ADDENDUM NO. 2
TO
BID DOCUMENTS BID #2223-14
BARTLEM PARK SOUTH – PHASE 1
Cheshire, CT
January 11, 2023
NOTICE TO BIDDERS

The following clarifications, modifications, deletions, and additions are hereby incorporated into and become part of the Contract Documents.

BARTLEM PARK SOUTH - PHASE I
 520 S MAIN ST,
 CHESHIRE, CT 06410

Drawing Title:
SITE PREPARATION & DEMOLITION PLAN

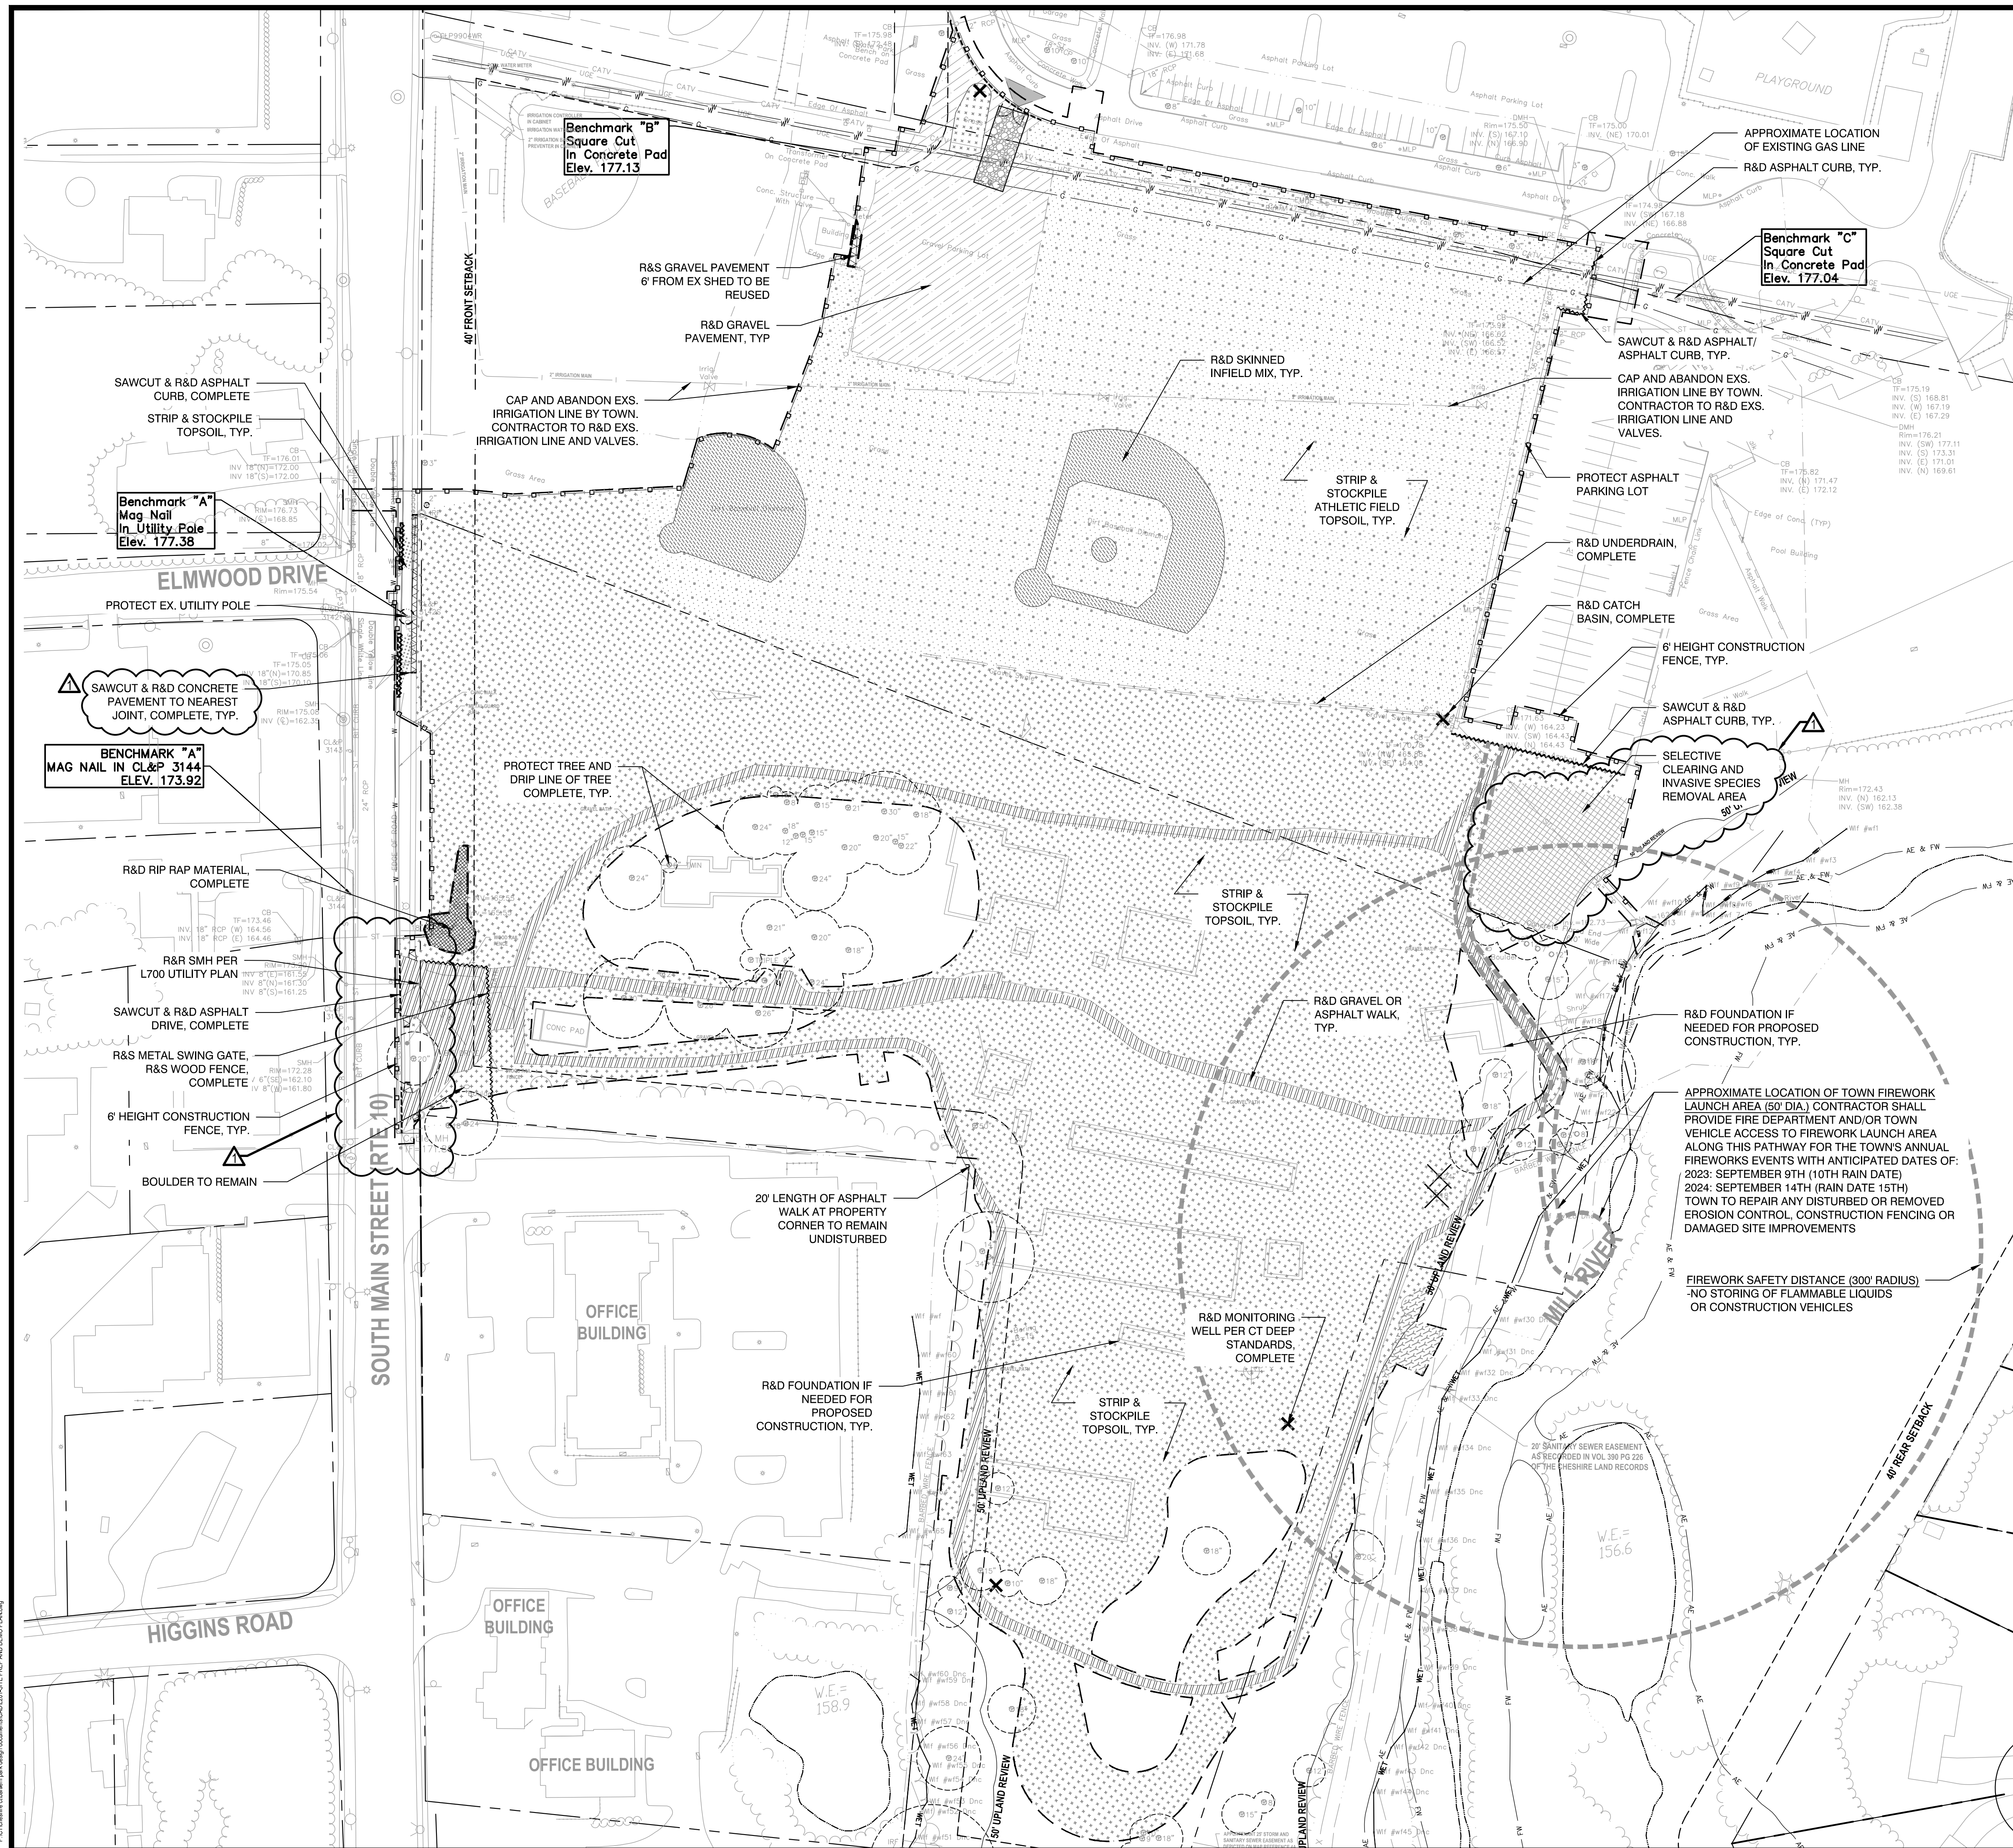
1. Sheet L201 revised, see attached.

DELETE: Sheet L201
ADD: Sheet L201 revised 1/31/2023
ADD: Selective Clearing of Invasive Species just south of the existing parking area.
ADD: Concrete walk removal to nearest joint along Route 10.
